APPEAL SUMMARY

Appeal ID: 27754

Project Address: 550 SE MLK Jr Blvd

LUR or Permit Application No.: 21-084383-CO

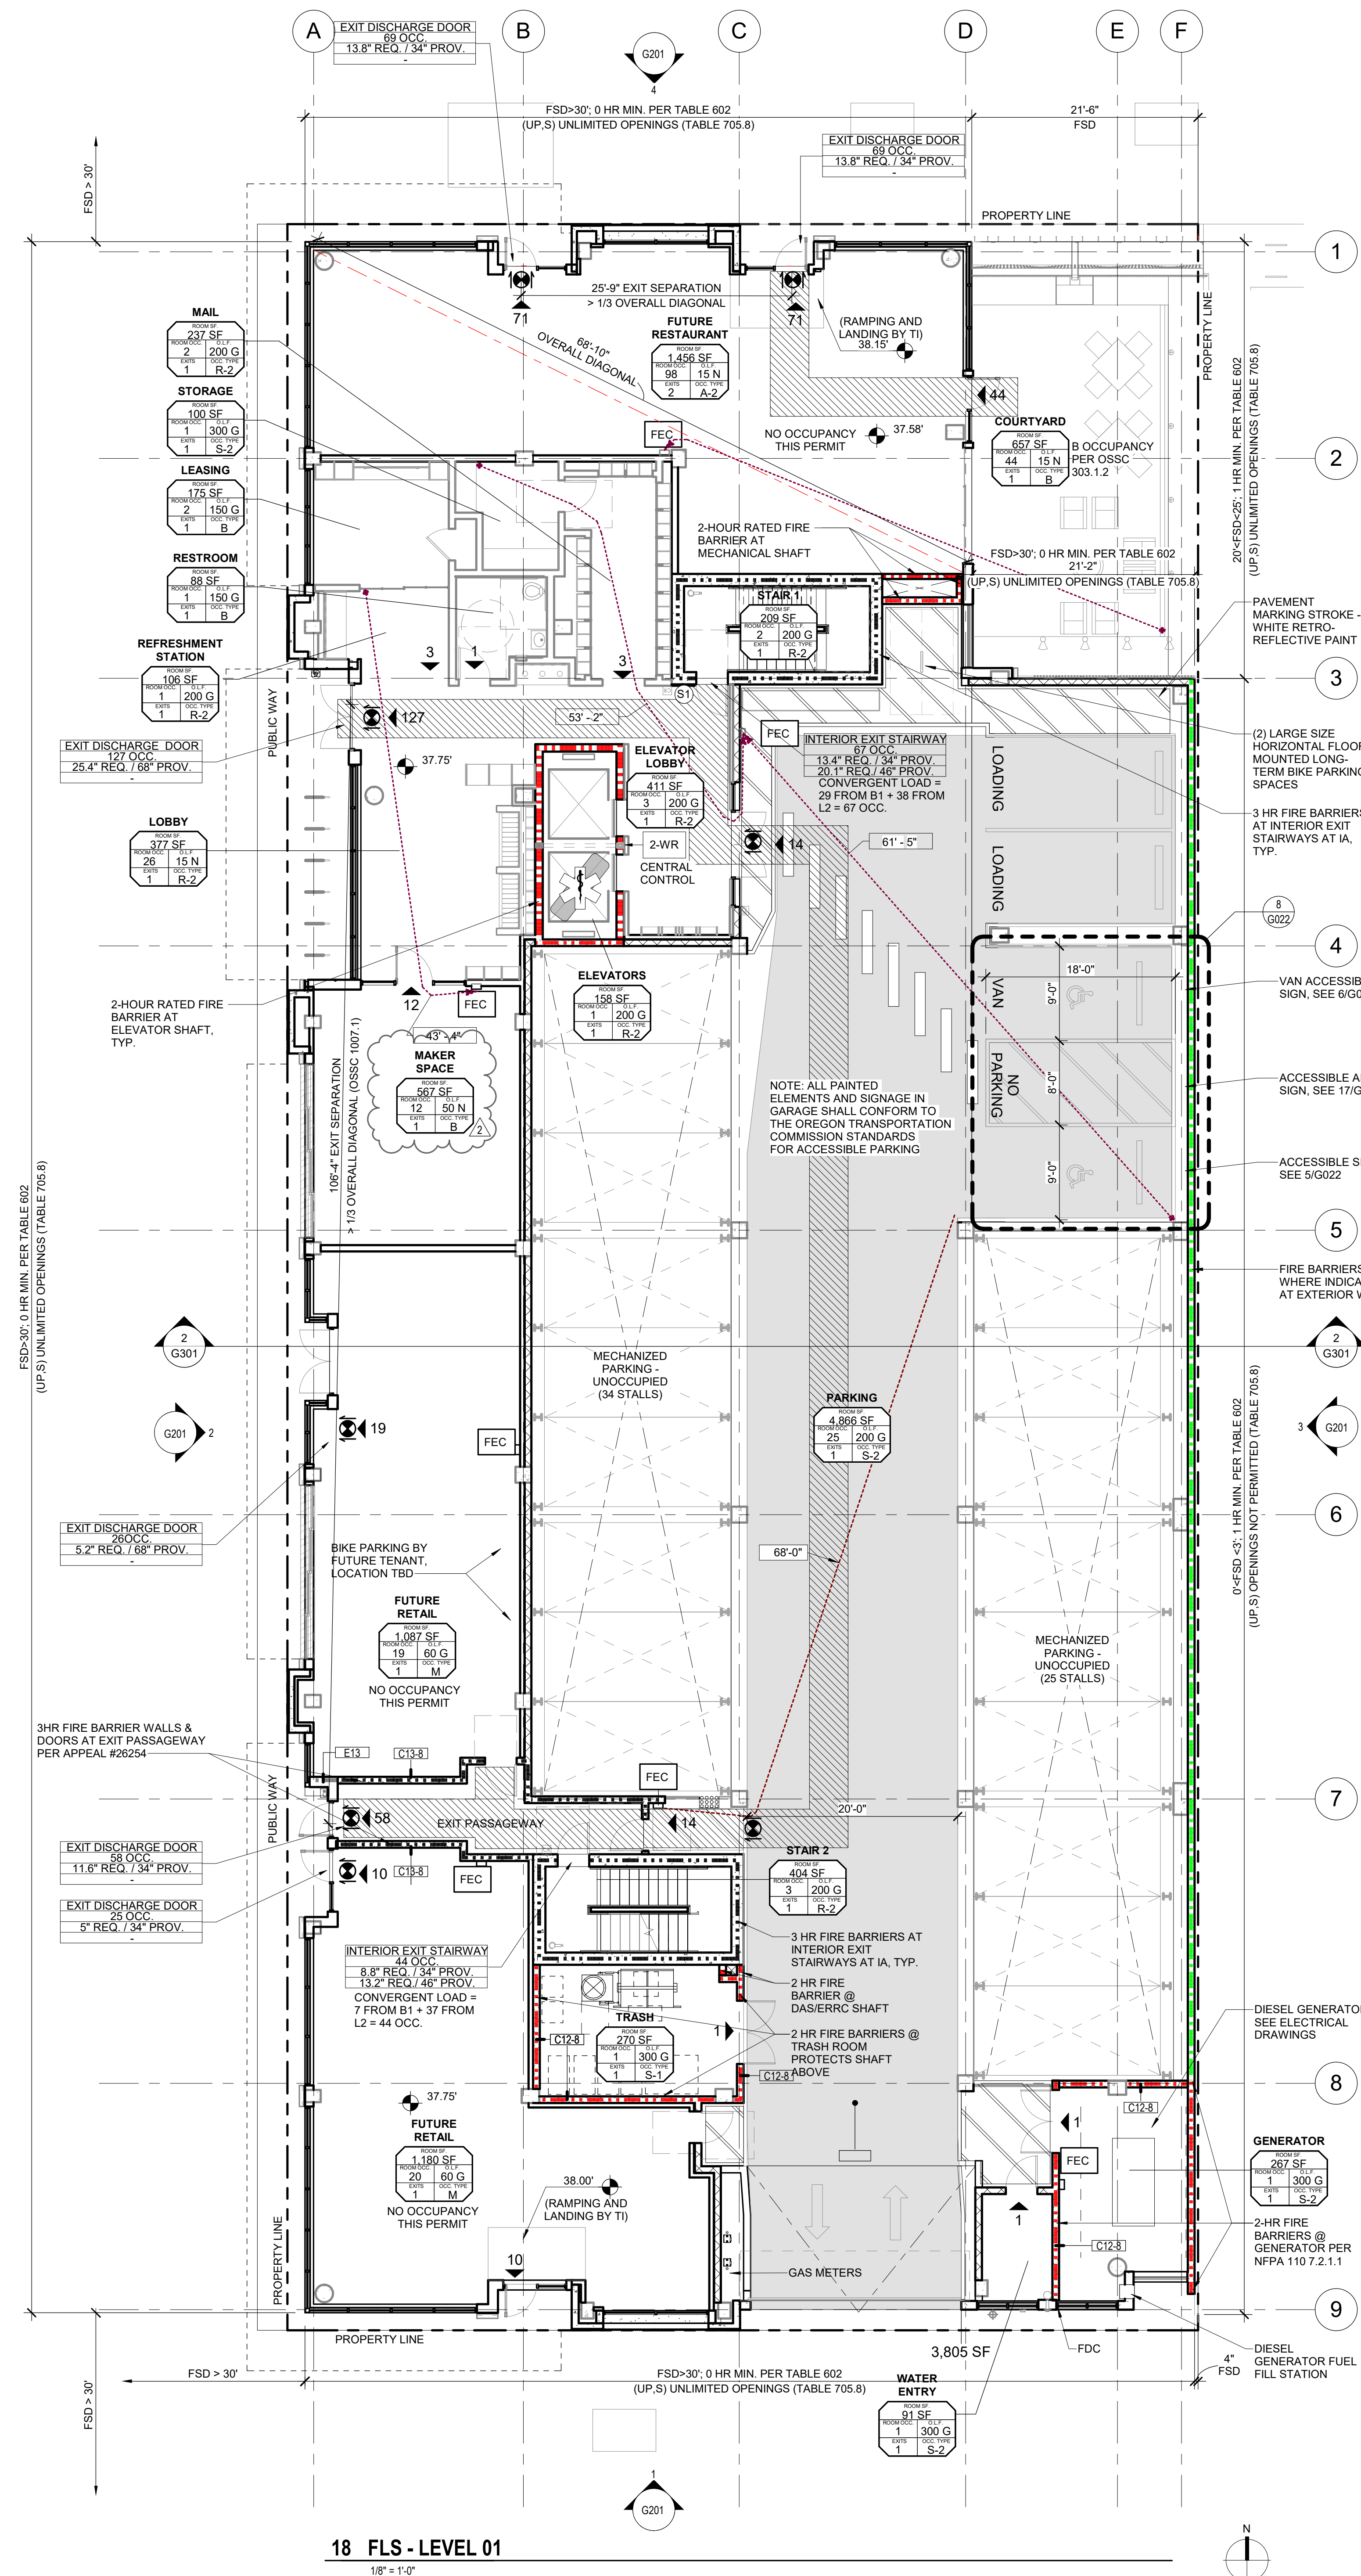
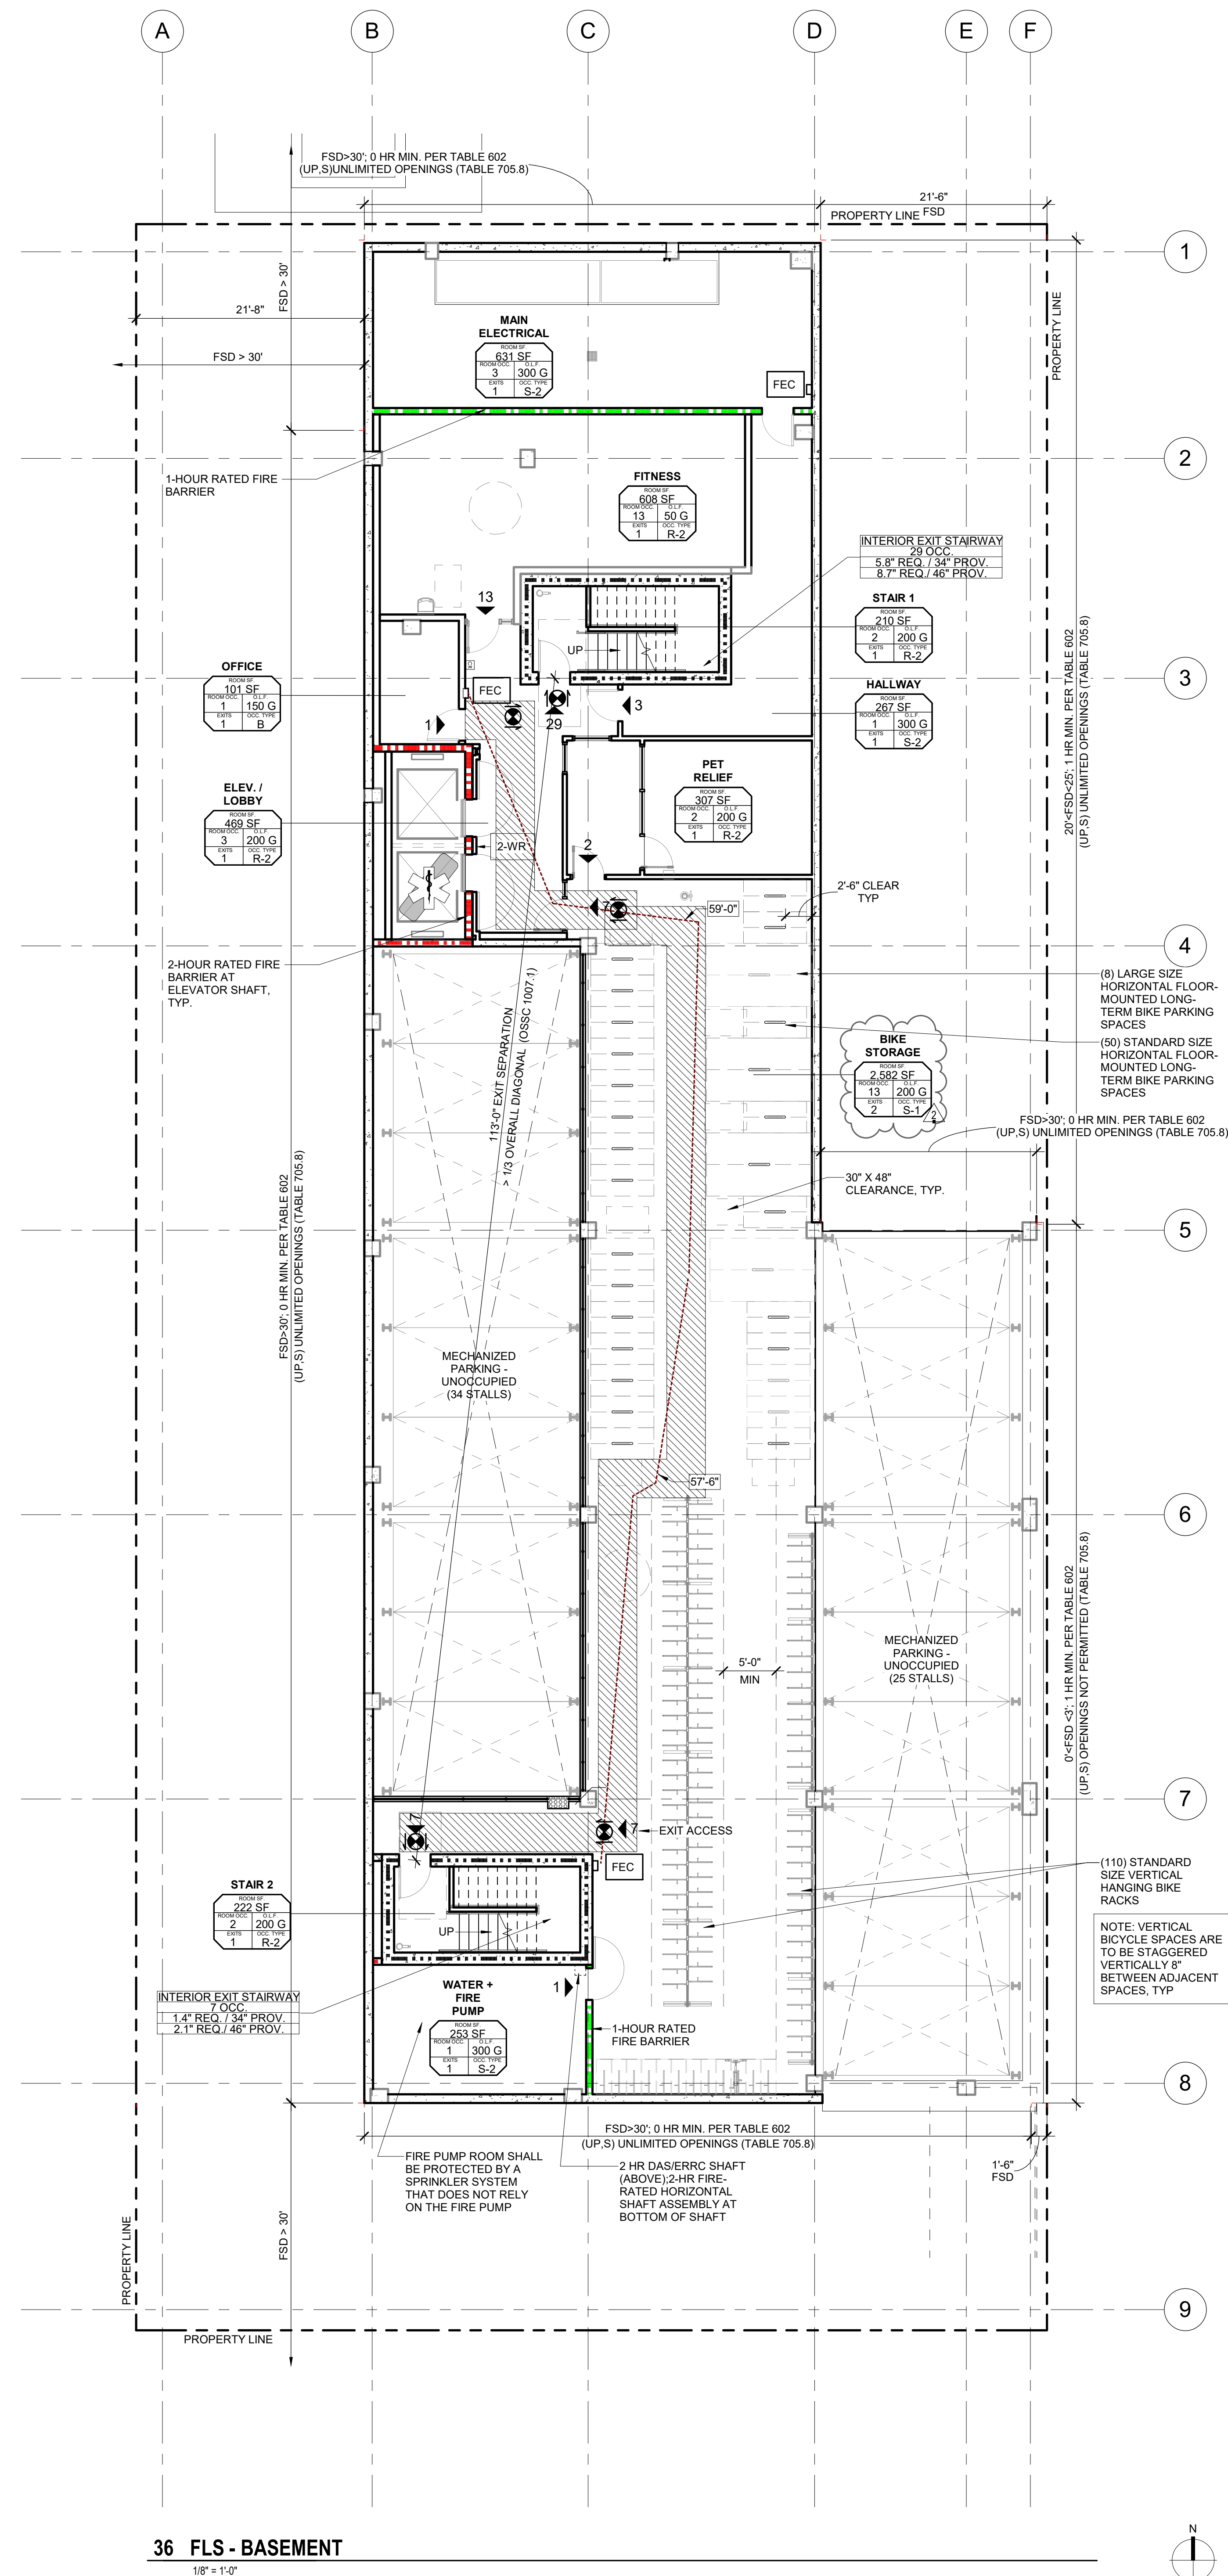
The Maker Space at Level 1 is used for short term/transient, miscellaneous craft and creative uses by residents; as such it has been re-categorized as a B occupancy, the closest applicable occupancy for this small space (567 sf). See updated Code Plan G100. The remaining normally occupied R-2 spaces at the basement and Level 1 (Lobby, Elevator Lobby, Mail, Refreshment Station, Fitness, Pet Relief) are only occupied occasionally for short periods of time; the occupancy in those spaces is transient in nature. These spaces are ventilated with fresh air according to the mechanical code. The small basement pet relief and fitness spaces receive higher rates of ventilation than is required, and are also short term/transient occupancies. The stairs are a very small footprint and also have very transient occupancy. These factors effectively make the need for radon mitigation unnecessary. The upper level non-transient R-2 occupancies are protected by this cushion of ventilated space at Level 1 and Basement. See updated G100 plan showing occupancy revision at Maker Space (now B), and A301 with the small short term/transient R-2 spaces at Level 1 and Basement highlighted.

Omission of radon mitigation at ground floor slabs: Granted provided the HVAC system in the in the common areas don't intermix with the HVAC system in the residential areas.
